DEVELOPMENT SERVICES DEPARTMENT – PLANNING DIVISION

September 21, 2016

**Subject: 2014 North Cirby Way, and 1202 & 1204 Samoa Way– Infill PCL 315 – Champion Oaks Rezone and General Plan Amendment Pre-Application– PL16-0263**

**ITEM V-A: GENERAL PLAN AMENDMENT, REZONE, GRADING PLAN & TREE PERMIT – 2009 N CIRBY WAY (PRIMARY APPLICATION ADDRESS) – DE MELLO REZONE – FILE #S: GPA 02-08, RZ 02-04, GP 03-19, & TP 03-30.**

# REZONE EXHIBIT for SUNSET WEST EXECUTIVE COMMUNITIES

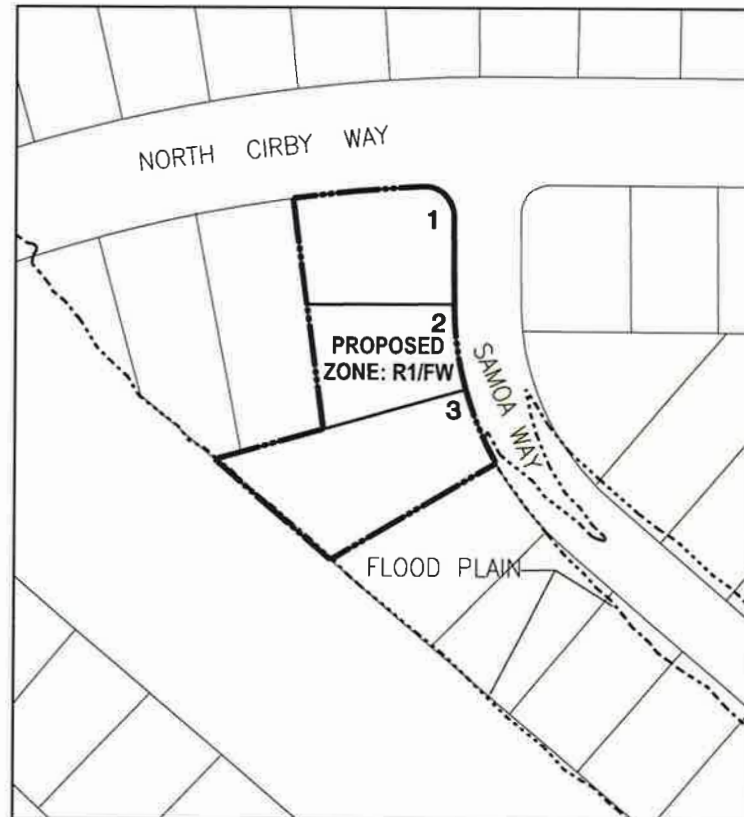
In review of the proposed project (Attachment 3, Rezone Exhibit) the City has identified the following:

- The proposal is inconsistent with the City's General Plan Policies:
- The proposal is locating residential housing in an area that has a documented history of flooding;
- The introduction of residential housing in an area designated as a flood hazard area and designated Floodway Zone district is inconsistent with the City's Zoning Ordinance;
- Past City actions by the Planning Commission has not supported modification of the General Plan or Zoning for properties in this area; and,
- The introduction of additional residential uses in flood prone areas does not support the health, safety or welfare of the existing and potential future residents of Roseville.

It is for these reasons that the City cannot support this project proposal. Although it is not supported as a viable development proposal, you have every right to submit a formal application to amend the General Plan land use and rezone the property.
